The 6th Regional Stakeholder Forum

Second Regional Information Sharing on Pak Lay Prior Consultation Process

Second Draft Technical Review on Hydrology & Hydraulics

Dr. Janejira Chuthong, Chief Hydrologist, MRC Secretariat

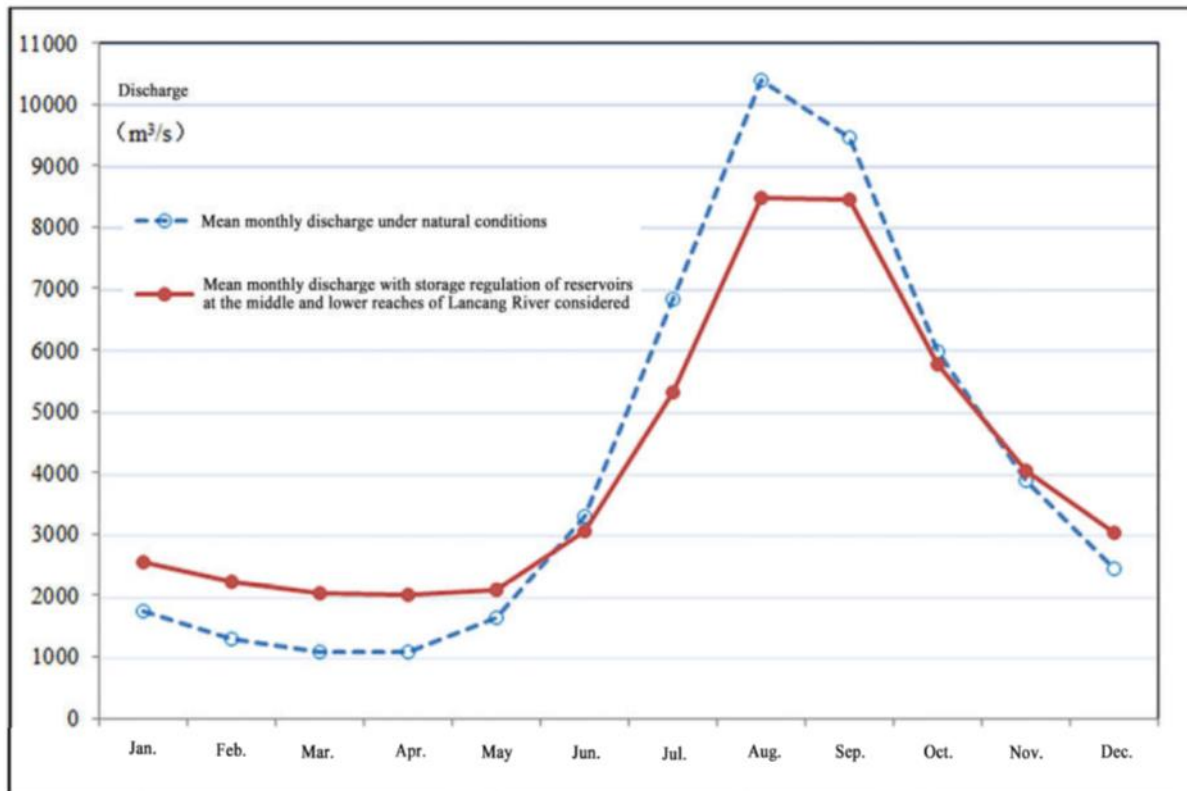
- The linear scaling approach (scaling Luang Prabang and Chiang Khan data) used to correlate the discharges is acceptable for monthly flows, but not for daily flows. These synthesized discharge data have not yet been checked with the observations at the dam site.

More analysis needed:

- Impacts of upstream developments only consider the Lancang cascade, but not the Laos tributary schemes and the Pak Beng and Xayaburi schemes
- Impacts of climate change are not included in the used forecasted series

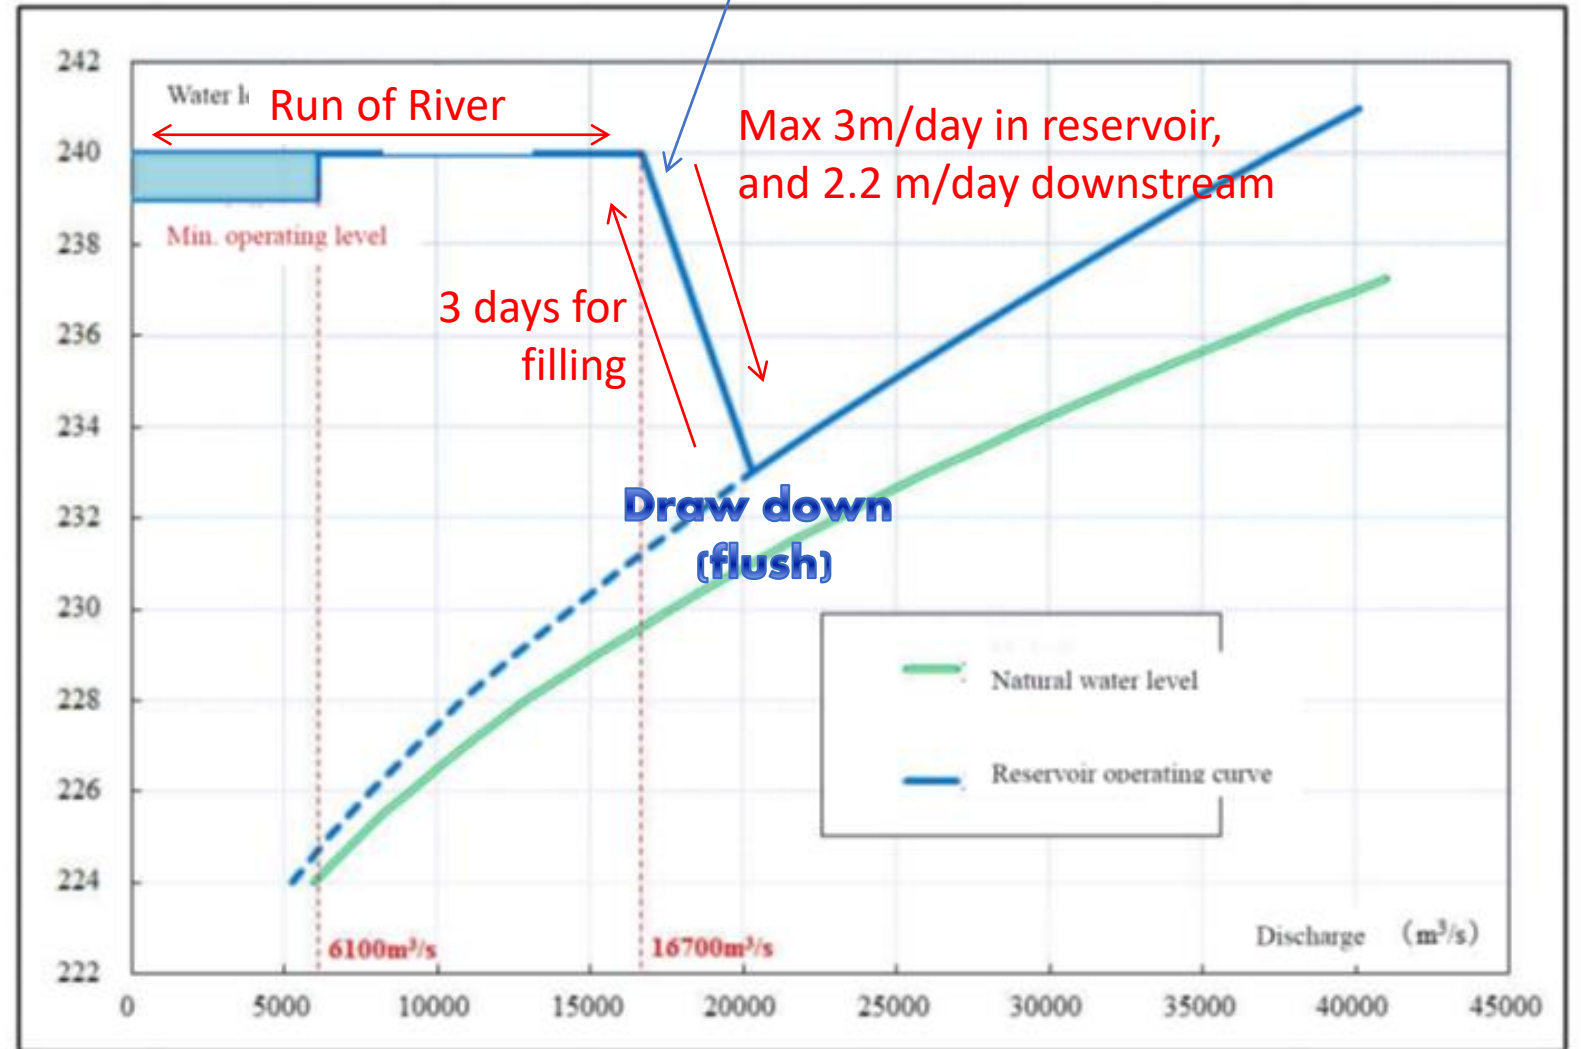
- Start emptying and filling at 16700 m³/s
- During high floods, draw down for sluicing and 'open channel'
- Most of time operation is "Run of River", and includes hydropeaking operation at low flows
- However, joint operation, transboundary impact of operations during flood, and environmental flow are not elaborated

Return period (=2 years) (may change due to future developments)
Draw down should be aligned with flushing in the cascade

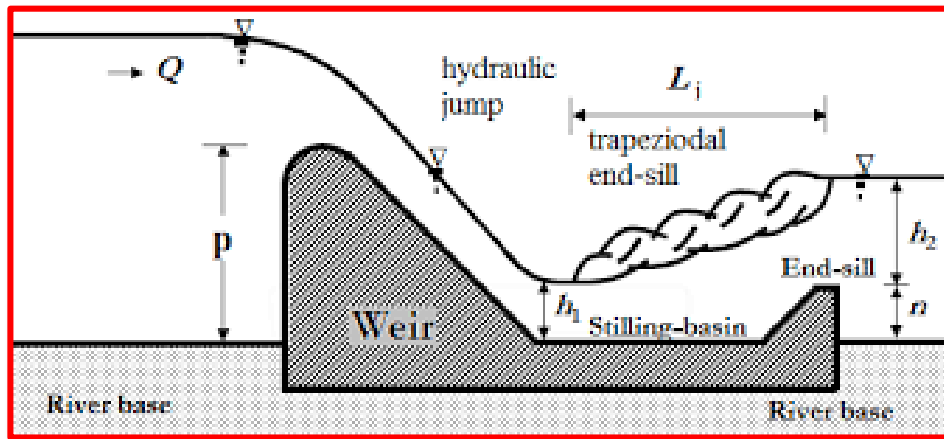
- the downstream impacts of the peaking operations, causing daily fluctuations of flows and water levels: impacts and mitigation need to be addressed in more detail
- The reduction of flow velocities in the impoundment during low flows: impacts to ecology and sediment load need to be considered properly

Graph: length L ranges from 88 to 132 m

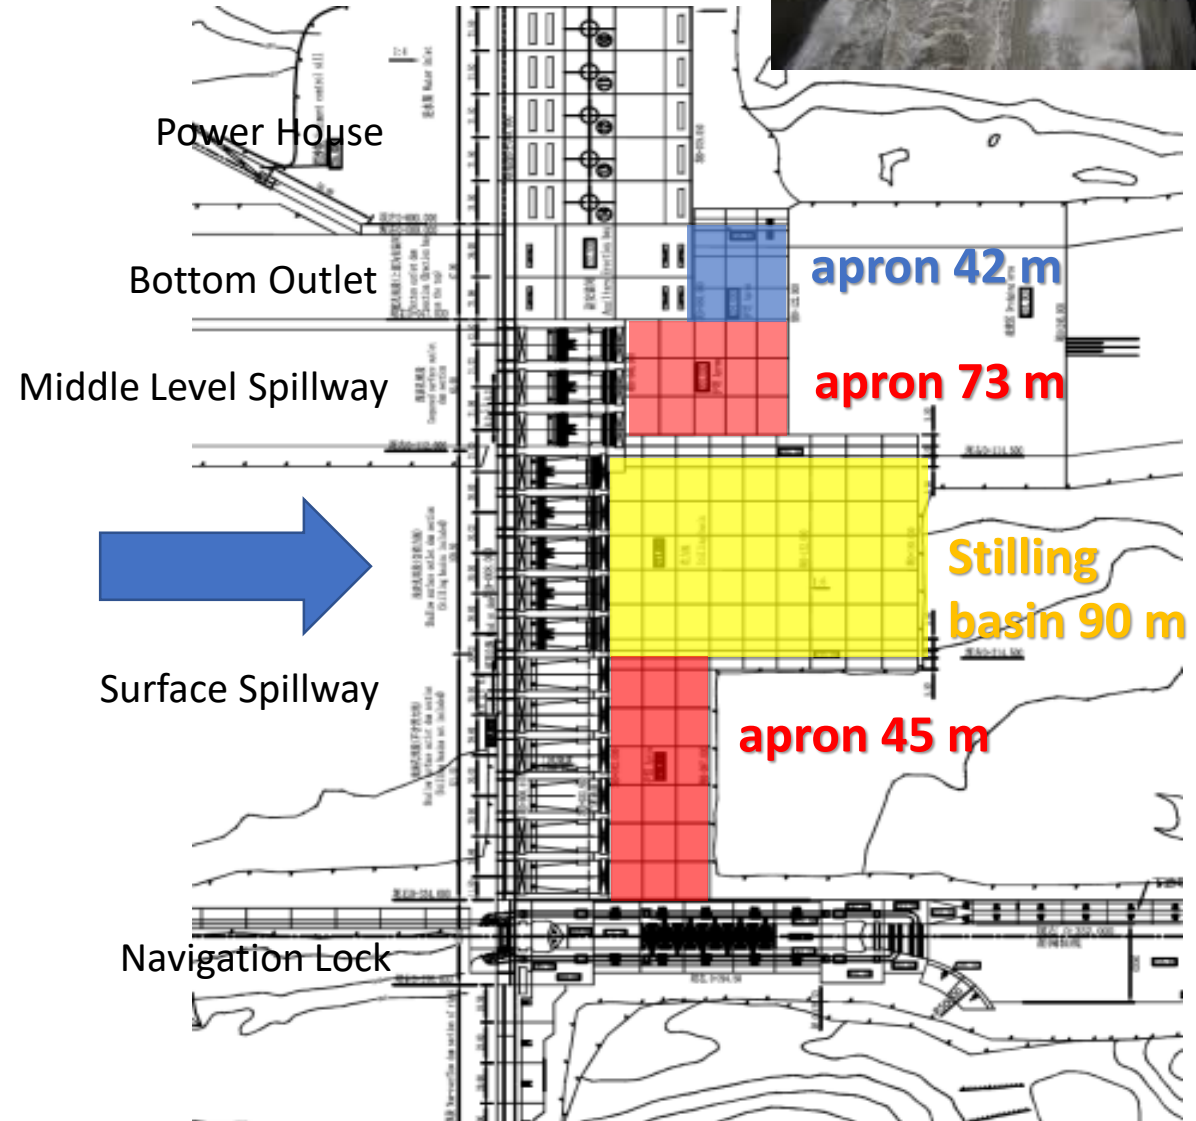
- The stilling basin and aprons downstream of the spillways are needed to protect the toe of the structure against erosion and damage by the turbulent outflows.
- More details of calculations and model tests must be presented to comprehend the chosen lengths.

The hydraulic jump determines the length of the stilling basin
